**Increase in size of containment cell and changes to
removal of drainage outfalls at McCabe St,
Mosman Park (Assessment 993)**

Landcorp and Octennial Holdings Pty Ltd

Proposed changes to Environmental Conditions

**Environmental Protection Authority
Perth, Western Australia
Bulletin 807
February, 1996**

Figure 1.3. Extended containment cell design

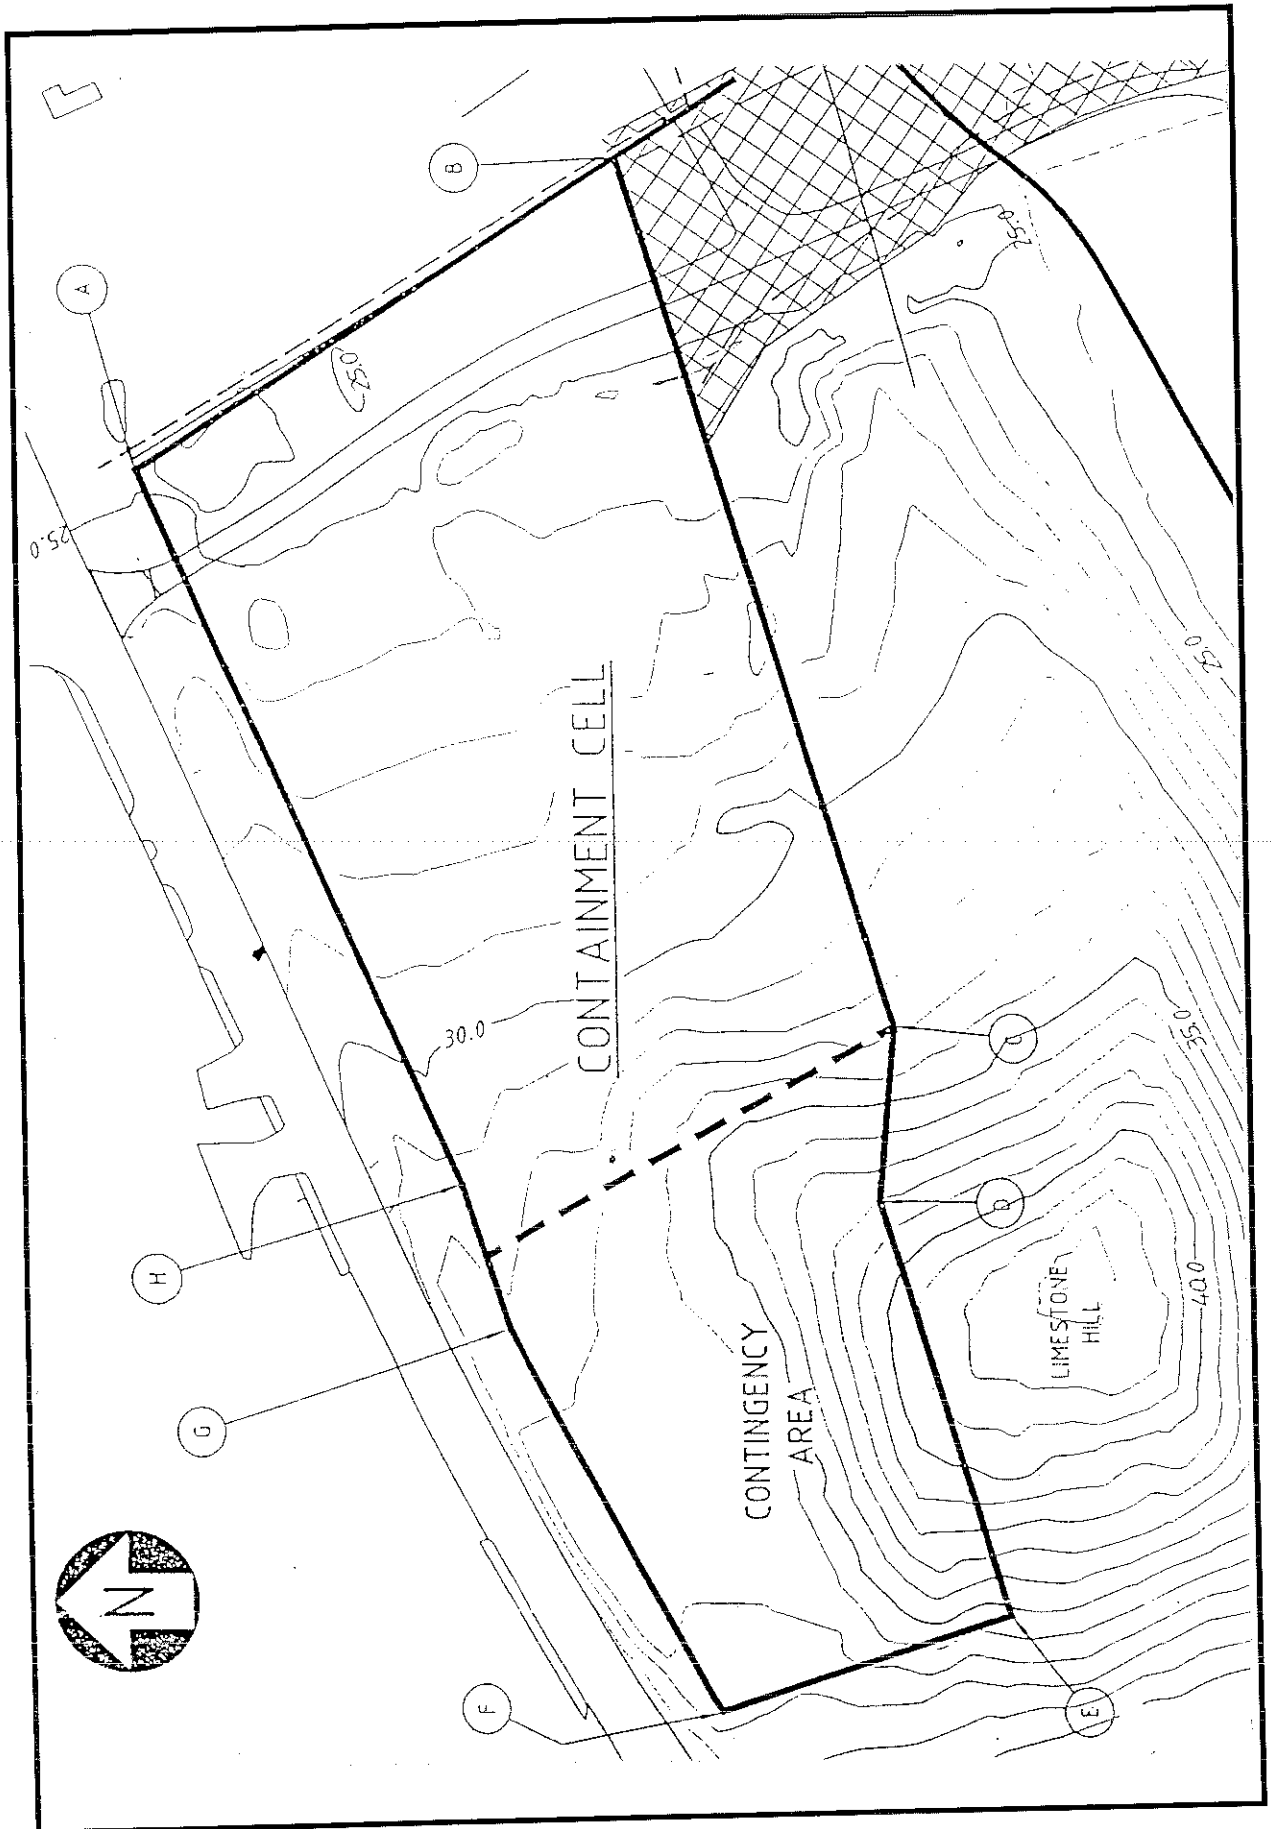
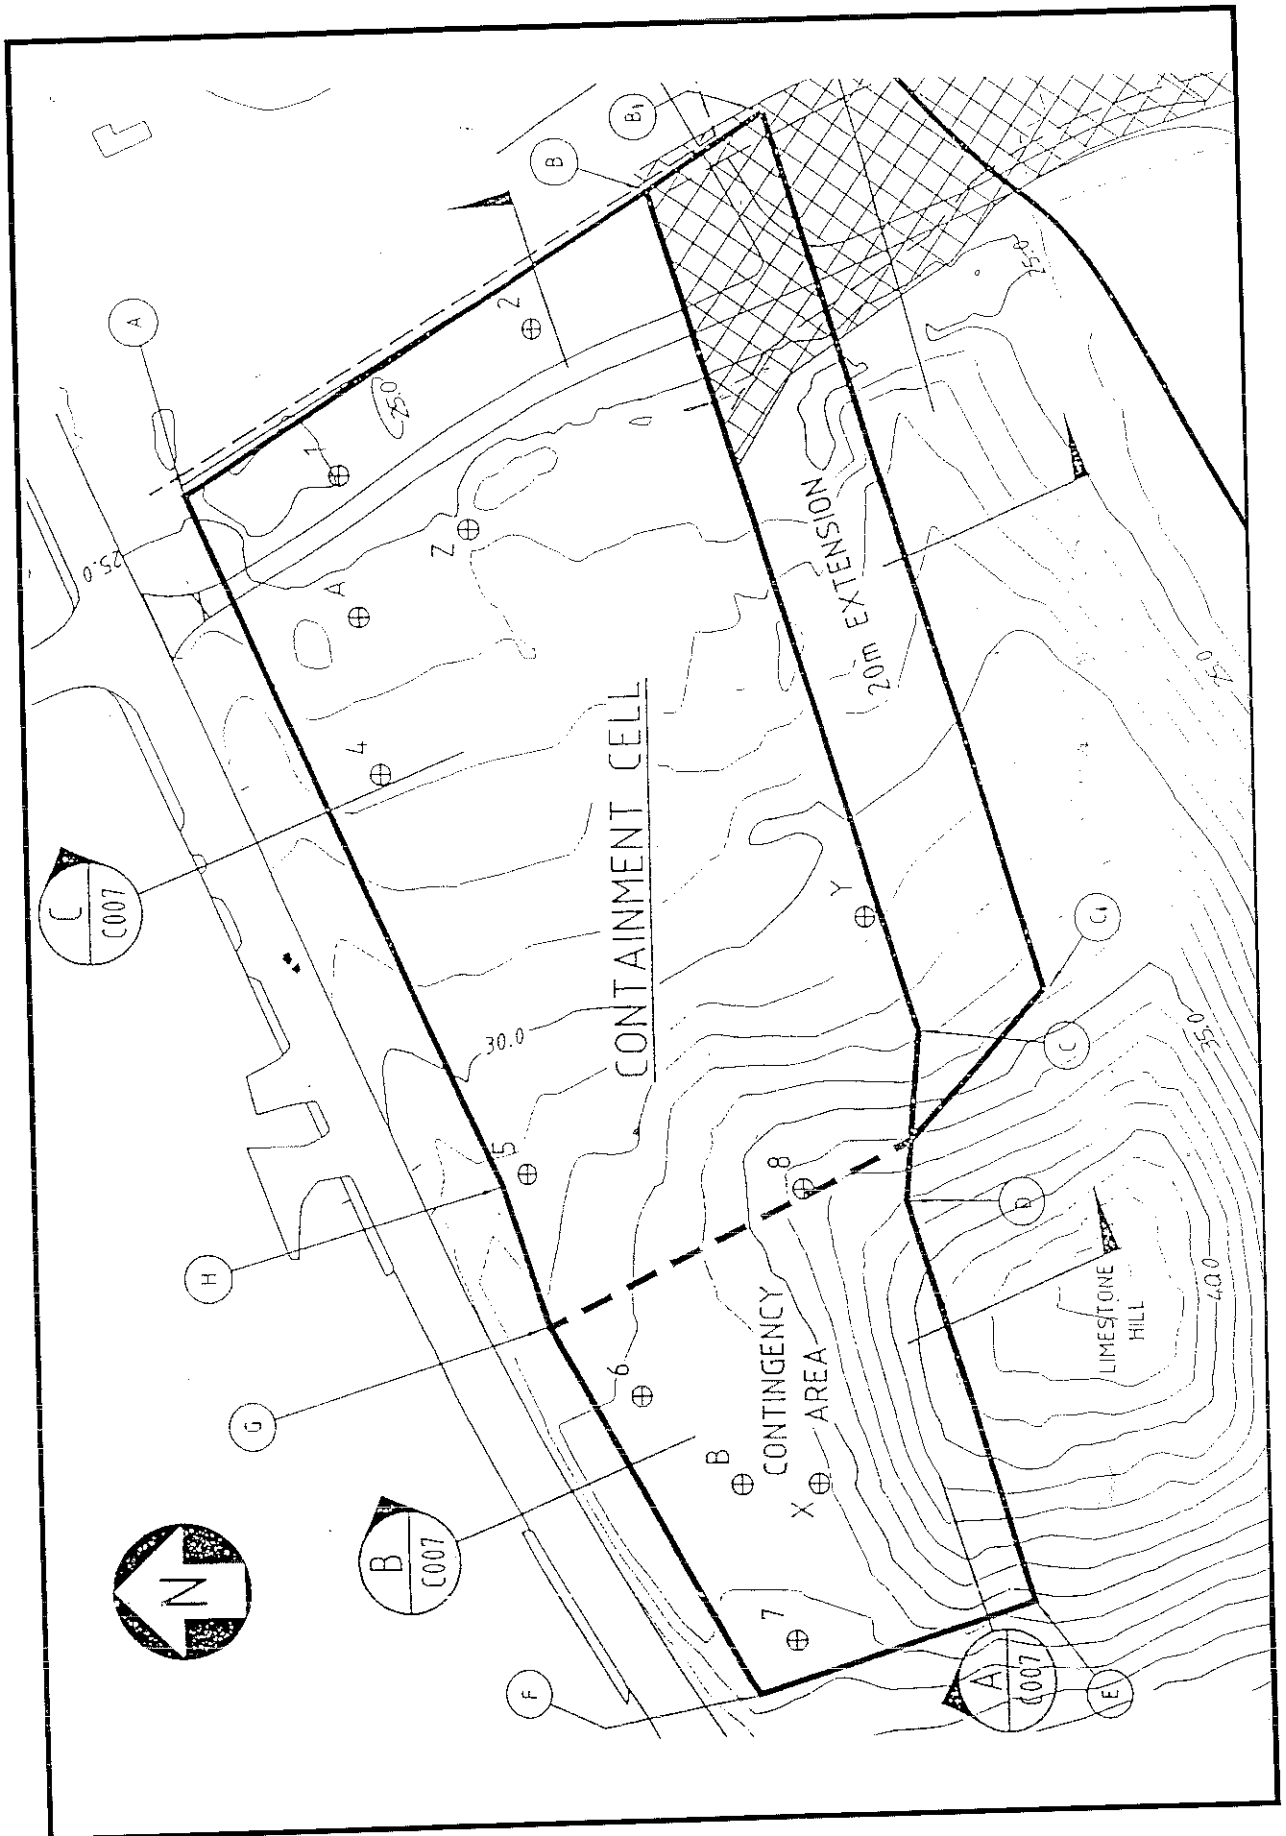
Implementation of the clean-up proposal to date has resulted in the identification of the need to increase the available volume of the original containment cell shown in Figure 1.2. The principal reasons for this change are:

Implementation of the clean-up proposal to date has resulted in the need to increase the available volume within the original containment cell shown in Figure 1.2. The principal reasons for this change are:

- an increase in the volume of limestone material affected by acid leaching beneath the Western Plant Area resulting in an additional 16,000m³ of material requiring relocation into the cell;
- adjustment to the containment cell dimensions to allow for the retention of mature trees along the McCabe Street boundary of the site in the vicinity of the cell resulting in a reduction in the original cell volume by 3,500m³; and
- minor changes to the design of the slopes of the containment cell wall resulting in a reduction in cell volume by 4,810m³.

Figure 1.3 illustrates the proposed increase in the containment cell dimensions. The increase in size of the containment cell sought by the proponent will result in a total excavated volume of 277,000m³. A total excavated volume of 233,150m³ was originally proposed in 1993.

The Environmental Protection Authority in examining the Review Committee's report and following consideration of public and government agency submissions has concluded that the proposal to increase the size of the containment cell by 20% is environmentally acceptable. This conclusion is based largely on the recognition that the proposed modifications do not change the technical basis of the proposal. The containment cell concept is amended only by an increase in size; there is no consequential reduction in the efficiency or effectiveness of the cell.

CONTAINMENT CELL
LINER AND CAPPING DETAILS

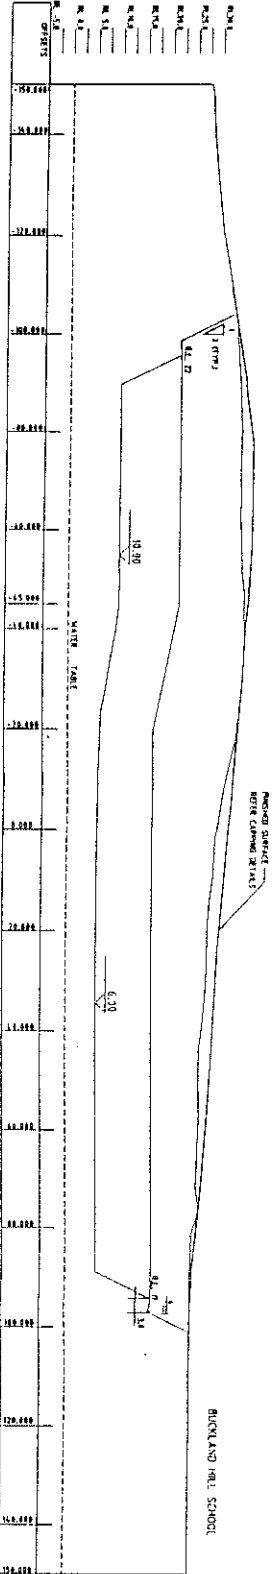
79. *Figure 2.1 shows a cross section of the pit but takes no account of topography which shows a drop of 6 metres south to north and more accurate representation of the cross section is given in attached figure 1. If the Proponents wish to maximise the volume of the pit and minimise the visual impact shouldn't they attempt to follow the contour of the natural surface?*

89. *Will the finished site be different from what is being provided by detail of figure 2.1? If so, what are the true details of construction?*

Figure 2.1 depicts a cross-section of the Containment Cell at the eastern end. If necessary the cell will be filled to within 1.55 m of surrounding natural surface levels and to slopes appropriate to achieve an evenly contoured finished surface but with positive drainage slopes to the outer edges in all cases.

The details presented in Figure 2.1 provide an indicative layout of the Containment Cell. Final cap levels and slopes will vary to allow finished ground levels to blend with surrounding ground levels.

There is no intention to mislead with the presentation of Figure 2.1 but merely to identify the key design principles that can then be adapted to suit particular circumstances at various locations on the cell perimeter.
